SOLICITATION AMENDMENT MODIFICATION DE L'INVITATION

Title - Sujet Seawater System and Pumphouse Const	
Solicitation No. - N° de l'invitation EB144-190610/A	Amendment No. - N° modif. 002
Client Reference No. - N° de référence du client EB144-19-0610	Date 2018-07-20
GETS Reference No. - N° de référence de SEAG PW-\$PWA-104-5757	
File No. - N° de dossier PWA-8-80026 (104)	CCC No./N° CCC - FMS No./N° VME
Solicitation Closes - L'invitation prend fin at - à 02:00 PM on - le 2018-08-02	Time Zone Fuseau horaire Atlantic Daylight Saving Time ADT
F.O.B. - F.A.B. Plant-Usine: <input type="checkbox"/> Destination: <input checked="" type="checkbox"/> Other-Autre: <input type="checkbox"/>	
Address Enquiries to: - Adresser toutes questions à: Nowakowski, Leanne	Buyer Id - Id de l'acheteur pwa104
Telephone No. - N° de téléphone (902) 403-7112 ()	FAX No. - N° de FAX (902) 496-5016
Destination - of Goods, Services, and Construction: Destination - des biens, services et construction:

Public Works and Government Services Canada
M&S ENGINEERING
exp
CANADIAN COAST GUARD COLLEGE, SYDNEY, NS
MECHANICAL & ELECTRICAL UPGRADES
PROPOSED SEAWATER PUMPHOUSE
SECTION DETAILS
R.065476.711
CSK-01
E-PM/000-C-538447

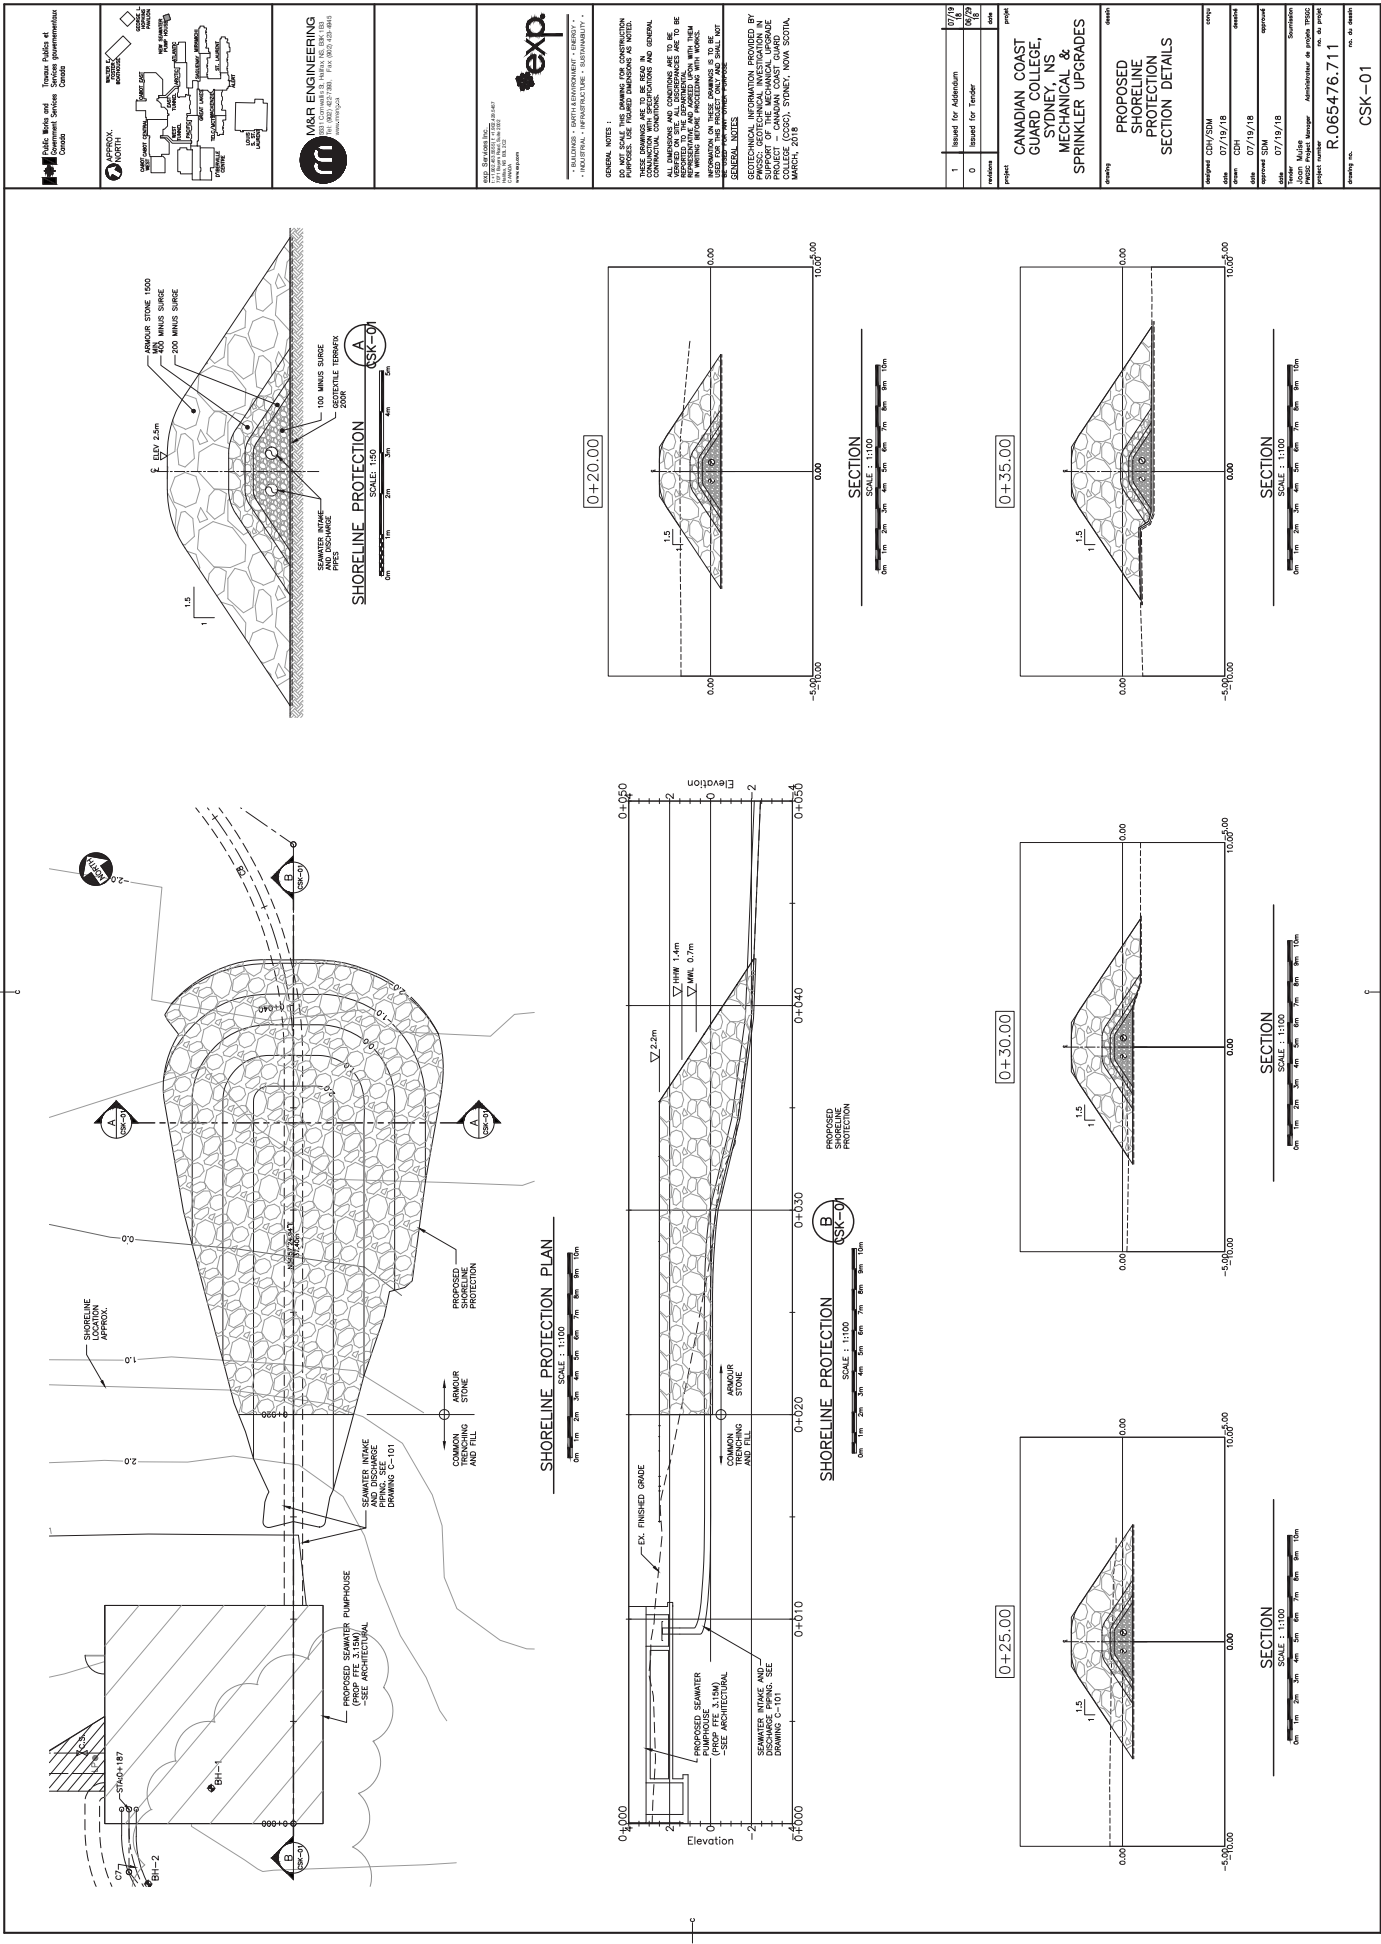
Q5 Can you please provide additional cross sections of the shoreline protection to aid in take offs and show the transition from shoreline protection to backfilled trench?

A5: Please see attached sketch "538447-12-CSK-01-SHORELINE PROTECTION-ADDENDUM"
